## 4T65E 1997-Up

**Application: General Motors 4T65E 1997-Up**

**Subject: Upper Channel Plate Gasket**

### 2nd Clutch Housing Rings

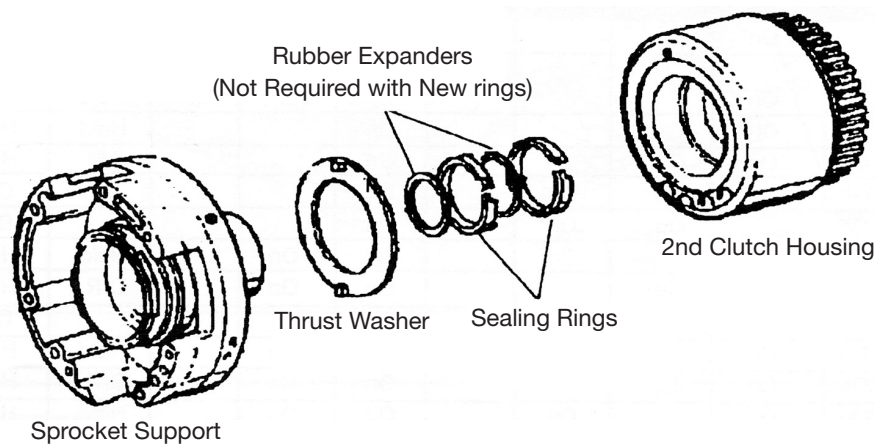
GM made a mid-model year change to the driven sprocket support that requires new 2nd clutch housing rings. The new rings do not retrofit back to the previous design support.

The new design 2nd clutch housing rings have a smaller width to fit the new design support, and one larger locking tab to prevent it from accidentally being installed on the previous design sprocket support.

The new support and rings no longer require the rubber quad expanders that were required in the previous design.

### Reverse Reaction Drum

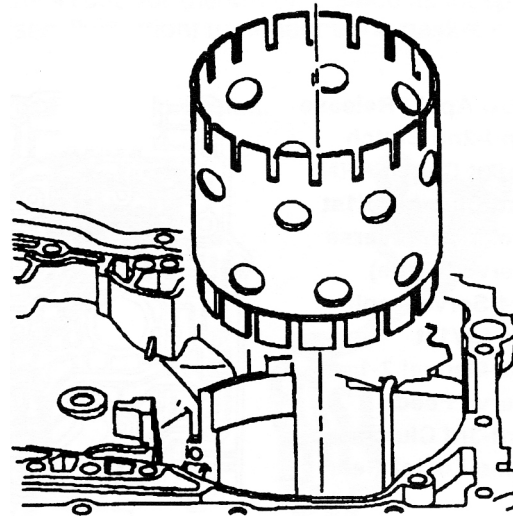
Note design change of reverse reaction drum. This also affects the 2nd clutch drum as well as the input carrier.

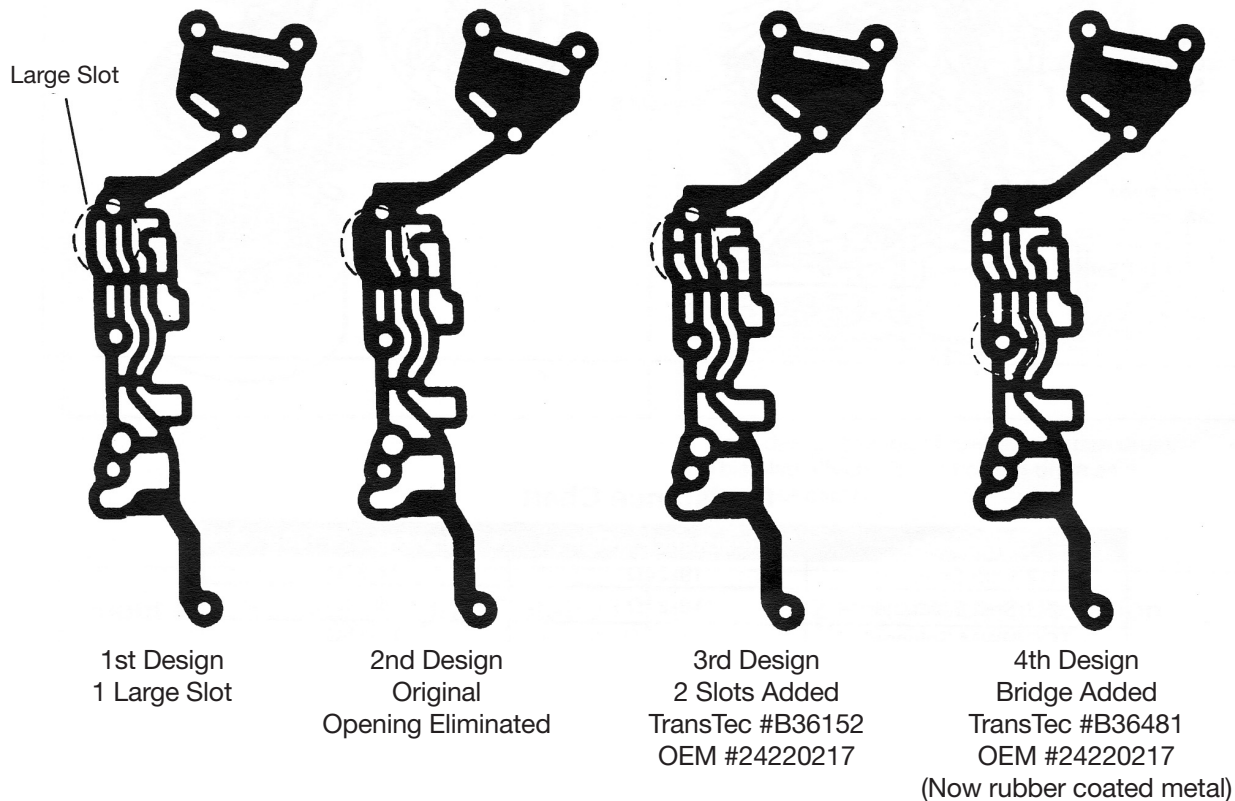
General Motors has changed the upper channel gasket for the 4T65E for the 4th time since its inception. In the latest revisions, GM has added a material bridge (see illustration) to enhance the gasket's strength in order to reduce the possibility of gasket blowout.

**Note:** GM did not change the OEM part (24220217) for the latest design.

### Input Clutch Inner Lip Seal: Short Lip Design Changed to Long Lip

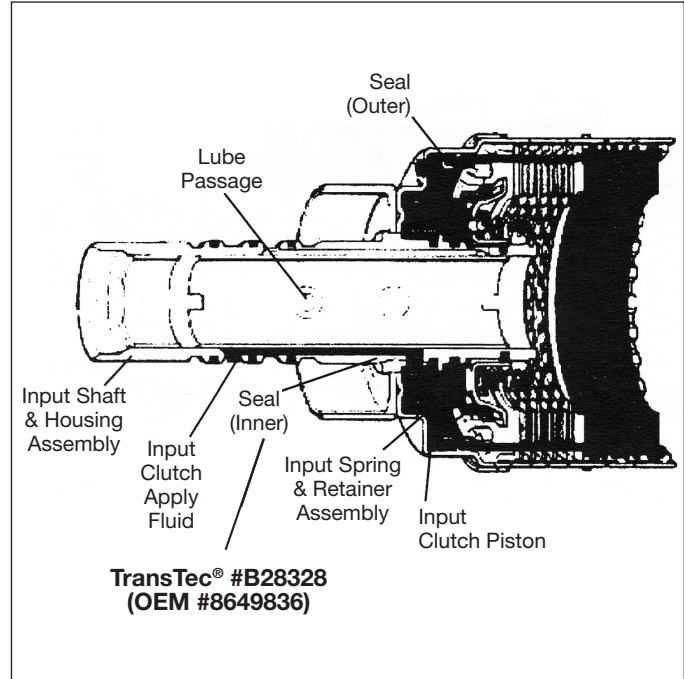
GM has used a “short” lip design seal for the 4T60/E input clutch inner location since approximately 1991. The short lip was used with the introduction of the “E” model, and through the end of 4T60 production in 1993. It was also used in the 4T65E since 1997. The short lip design seal was used for ease of assembly at the factory, as well as its cost savings over a molded, “long” lip seal.

It has been shown, however, that in this application a long lip design seal will outperform the current O.E. short lip type. Using a long lip seal has also been a rebuild recommendation from various tech services.

We have, therefore, switched the current input inner short lip seal to a long lip seal. The long lip seals are in all TransTec® brand gasket/seal and overhaul kits with date codes of F99 and later.

### Short Lip Seals Replaced by Long Lip Seals

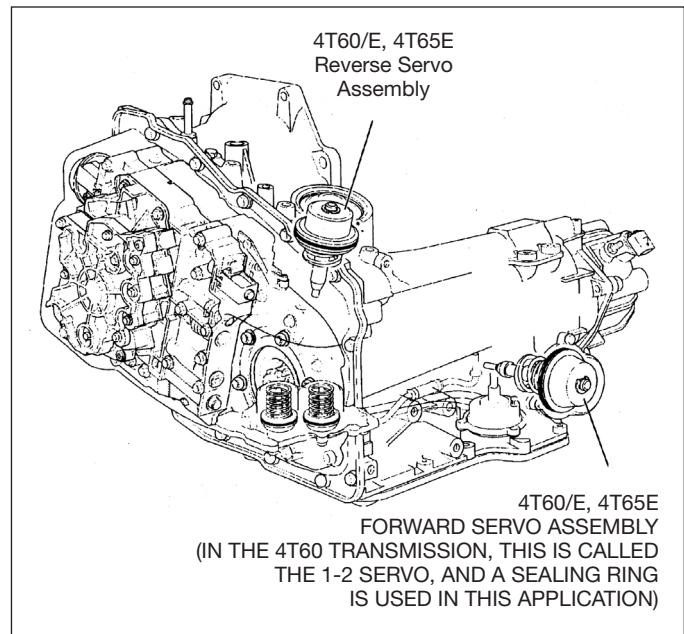
GM has used a “short” lip design seal for the 4T60/E and 4T65E reverse servo piston since 1985. The short lip was used in the 4T60 through the end of production in 1993, all of 4T60E production, and in current 4T65E production. The short lip design seal was used for ease of assembly at the factory, as well as its cost savings over a molded, “long” lip seal.

It has been shown in this application, however, that a long lip design seal will outperform the current O.E. short lip type. Using a long lip seal also has been a rebuild recommendation from various tech services, as well as through bench testing and field testing.

Therefore, we have switched to a long lip design seal for the reverse servo in the 4T60, 4T60E and 4T65E, and the forward servo in the 4T60E and 4T65E. The long lip seals are in all TransTec® brand gasket/seal and overhaul kits with a date code of B03 and later.

**Subject: Valve Body Gaskets**

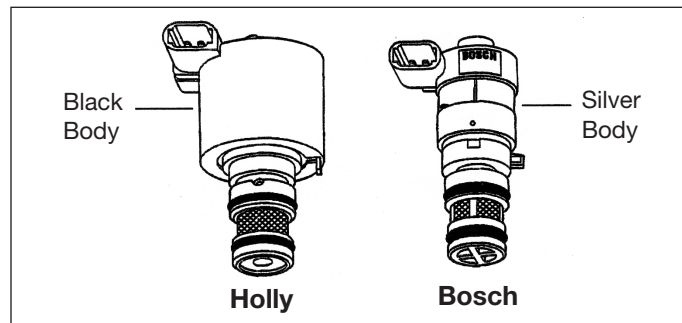
In 2004, GM offered the 4T65E with a manual shift option under a regular production order (RPO) code of KB7). The Pontiac Grand Prix was the first to offer this option to consumers with other applications to follow.

The valve body gaskets in sub kit 4781 are to be

used on 4T65E applications that have the manual shift option. The valve body gaskets that are loose in the main kit are for units that do not have the manual shift option.

**Subject: Molded Pan Gasket**

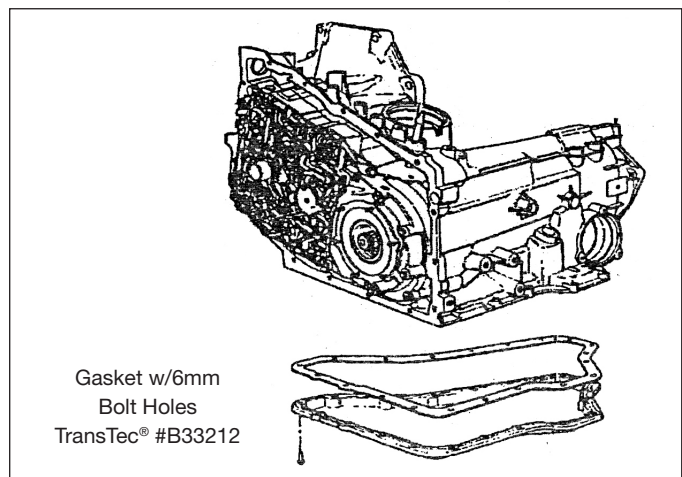
Since its inception in 1997, GM has used a molded rubber pan gasket on the 4T65E. The original molded gasket, as well as the pan and case, required 8mm bolts. In mid-year of 1998, GM changed the bolts from 8mm to a 6mm shank, along with the case and pan to accommodate the new bolts.

Since the number of later models requiring the 6mm bolt pan gasket is far greater than the previous 8mm design, all kits with a date code of A06 and later contain the 6mm gasket. The early 8mm molded pan gasket will still be available for bulk sales.

Part #B32542 covers 1997 to early 1998 with 8mm bolt holes and part #B33212 covers early 1998-up with 6mm bolt holes.
